ORIGINATION FORM

Proposed Revisions to a Standard Plans Index
(Please provide all information — Incomplete forms will be returned)

Index Number: 521-423

Index Title: Traffic Railing - (32" Vertical Shape)

LAST REVISION 11/01/18	REVISION	DESCRIPTION:		FY 2020-21 STANDARD PLANS	TRAFFIC RAILING - (32" VERTICAL SHAPE)	INDEX 521-423	SHEET 1 of 3
---------------------------	----------	--------------	--	------------------------------	--	------------------	-----------------

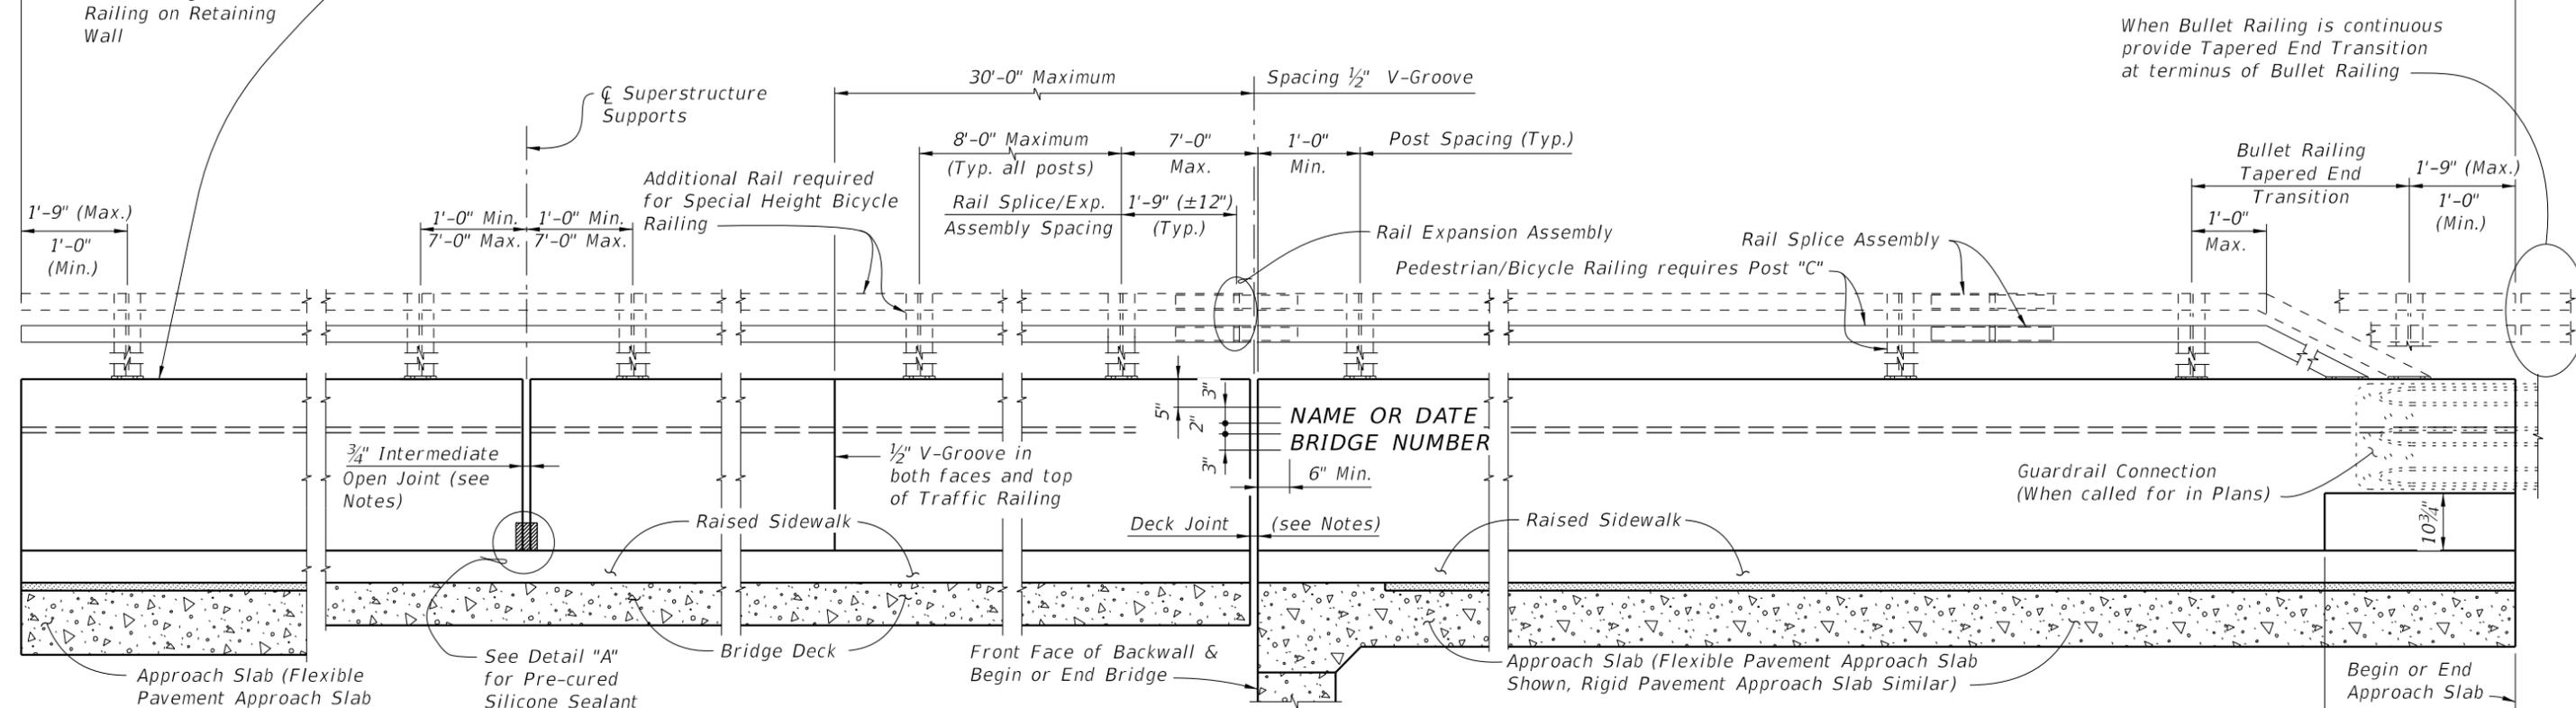
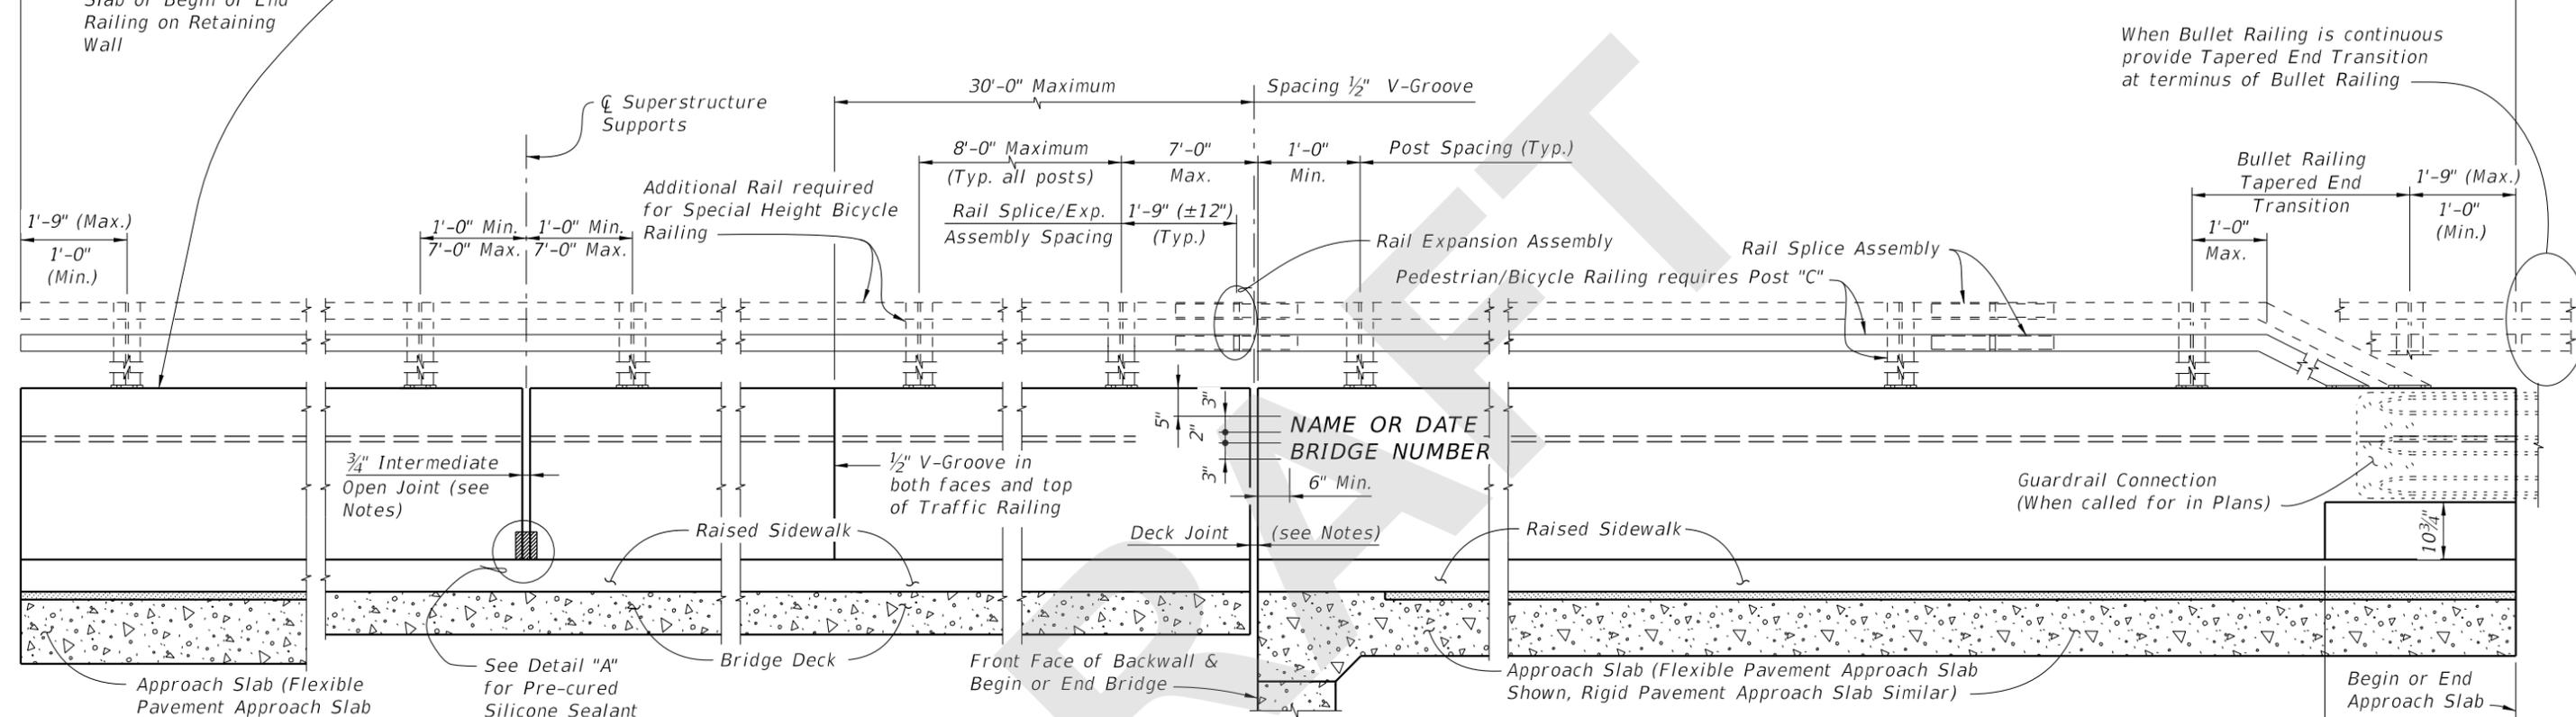
Numbered and reorganized Notes; Deleted MASH note.

MASH crash criteria met is in the SPI (not a construction note). Numbered notes to make them consistent with other Indexes.

~~This railing has been structurally evaluated to be equivalent or greater in strength to other safety shape railings which have been crash tested to NCHRP Report 350 TL-4 and MASH TL-4 Criteria.~~

1. Materials: See Structures Plans, General Notes
2. Guardrail Connection Details: See Index 534-001
3. Traffic Railings may be constructed perpendicular to the sidewalk surface. If an adjoining railing is constructed plumb, transition the end of the Traffic Railing from perpendicular to plumb over a minimum distance of 20'-0". The cost of all modifications will be at the Contractor's expense.

4. Name, Date & Bridge Number: Place the Name and Bridge Number on the Traffic Railing on the driver's right side when approaching the bridge. Place the Date on the driver's left side when approaching the bridge. Use the Name as shown in the General Notes of the Structures Plans. The Date is the year the bridge is completed. For a widening when the existing railing is removed, use both the date on the removed rail and the year of the widening. Form letters and figures with 3/8" V-Grooves using preformed letters and figures. Black plastic letters and figures 3" tall may be used, if approved by the Engineer.

5. Open Joints: See the Superstructure Plans, Approach Slab and Retaining Wall Sheets for Deck Joint dimensions and orientation. Provide Open Railing Joints matching the dimensions of the Deck Joint at Deck Expansion Joint locations.

- A. For treatment of railings on skewed bridges see Sheet 3.
6. Open Joints: Provide 3/4" Open Joints at:
 - A. Superstructure supports where the slab is continuous.

- B. At ends of approach slabs when adjacent to retaining walls and at expansion joints on retaining wall junction slabs.

7. V-Grooves: Construct 1/2" V-Grooves plumb. Space V-Grooves equally between 3/4" Open Joints and/or Deck Joints and the at V-Groove locations on the Retaining Wall footing/junction slabs.
8. Barrier Delineators: Install Barrier Delineators on top of the Traffic Railing 2" from the face of the traffic side in accordance with Specification Section 705. Match the Barrier Delineator to the color (white or yellow) of the near edgeline.
9. For embedded conduit and junction boxes see Index 630-010.
10. For Traffic Railings with Pedestrian/Bicycle Bullet Railings see Index 515-021 and 515-022 for Notes, Details and post spacing.
